Product Category	MPU&MCU	Document No.	TN-H8*-A293A/E	Rev.	1.0
Title	Corrections of the Flash Memory Programming Procedure Flowchart (0.18- μ m F-ZTAT version)		Information Category	Technical Notification	
Applicable Product	HD64F2378	Lot No.	Reference Document	H8S/2378, H8S/2378R Group Hardware Manual (REJ09B0109-04000 Rev.4.00)	
	HD64F2378R	All lots

We would like to inform you of the following corrections of the flash memory programming procedure flowchart (0.18- μ m F-ZTAT version) in the H8S/2378 Group and H8S/2378R Group Hardware Manual.

4. Addition of the description of the FPFR determination (page 878 of 1088)

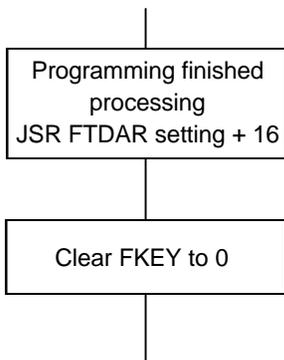
- 16. After programming finishes, clear FKEY and specify software protection.
If this LSI is restarted by a power-on reset immediately after user MAT programming has finished, secure a reset period (period of RES = 0) that is at least as long as normal 100 μs.

- 16. The return value in the programming program, FPFR (general register R0L) is determined.
- 17. After programming finishes, clear FKEY and specify software protection.
If this LSI is restarted by a power-on reset immediately after user MAT programming has finished, secure a reset period (period of RES = 0) that is at least as long as normal 100 μs.
